Subject: Mail Control No. 583820, Pratt & Whitney Responses to RAIs dated 7/14/14

Pratt & Whitney Responses to NRC RAIs dated 7/14/14

**Pratt & Whitney responses to the NRC request for additional information on the
Middletown Final Status Survey Plan dated 7/14/14**

**Termination of License SMB-151
at the Middletown, CT Facility**

Figure 4-3 Building 140 Survey Unit

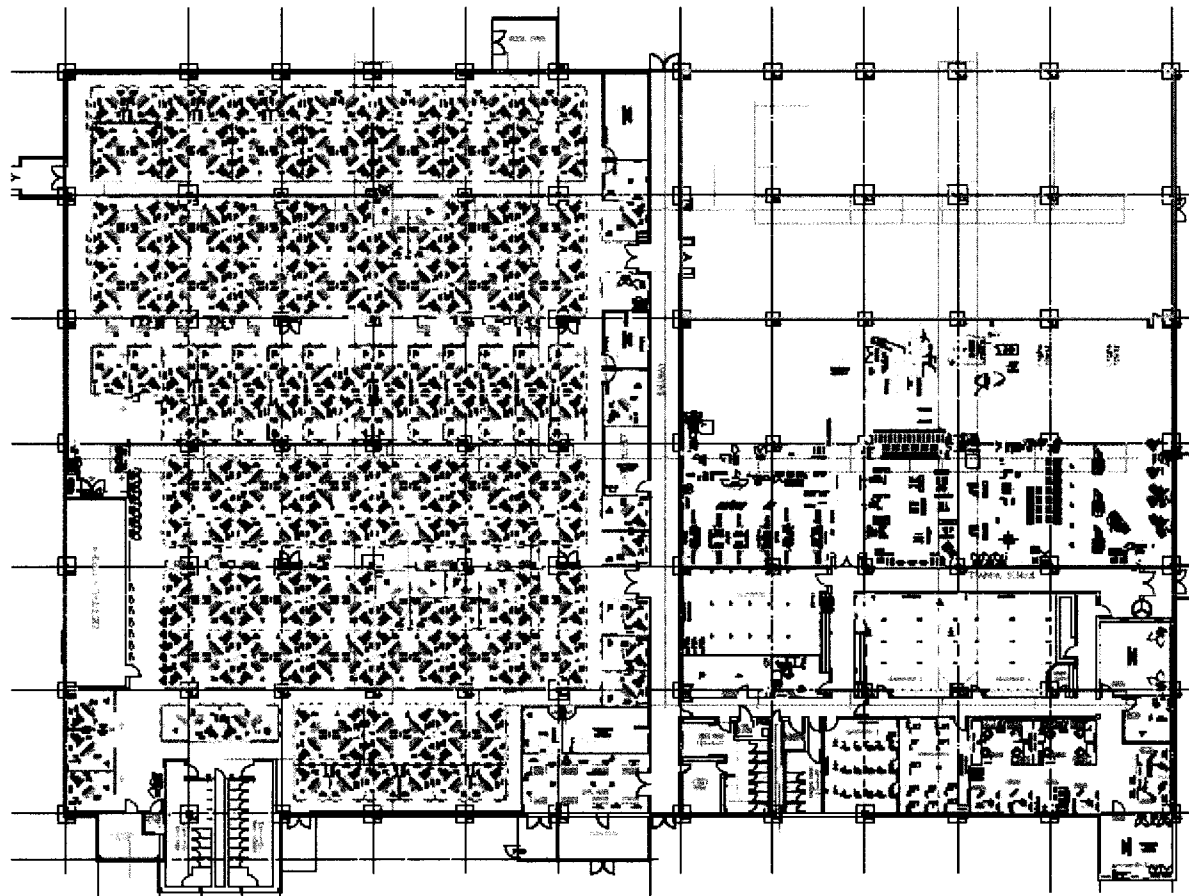
- c. Before release of the site, the licensee needs to demonstrate how the facilities impacted by licensed material meets the criteria in 10 CFR Part 20, Subpart E. The review of Building 140 provides insufficient survey and characterization to conclude that it meets the criteria in 10 CFR 20, Subpart E.

P&W response: P&W is unable to locate the details of the modifications to the laboratory and the remainder of Building B-140, as well as the surveys and characterization data from the NMRD Laboratory; therefore, we are unable to provide data to support the conclusion that it meets the criteria in 10 CFR 20, Subpart E. P&W will now include the entire Building B-140 in the Final Status Survey at the Middletown site.

- The Conclusion 1 now states "...a final status survey of Building B-140 will be performed."
 - Table 4-2 has a new survey unit 8 for the entire Building B-140.

- Figure 4-3 presents the current floor plan for Building B-140.
4. Section 3.0 of the FSSP-Middletown states that activities in Building 10 ceased in 2000 and the building was demolished in 2004. Although it states that the building was since "terminated" from the license, the NRC did not review the surveys of the building until many years after its demolition. As stated in the letter from the NRC dated August 26, 2013, only the remaining concrete pad from Building 10 was released for unrestricted use by the NRC. We note that Building 10 was not released for unrestricted use by the NRC prior to its demolition; instead, in 2013, the NRC evaluated the available data from surveys performed in 2000, as described in the NRC Inspection Report No. 040-00791-12-002 dated July 22, 2013, to determine that the building most likely met the Subpart E release criteria. The FSSP-Middletown section "Building 10 Decommissioning and Final Status Survey Report" addressed only the surveys of the remaining Building 10 concrete pad. Please correct Section 3.0 to state that only the remaining concrete pad from Building 10 was released for unrestricted use by the NRC.
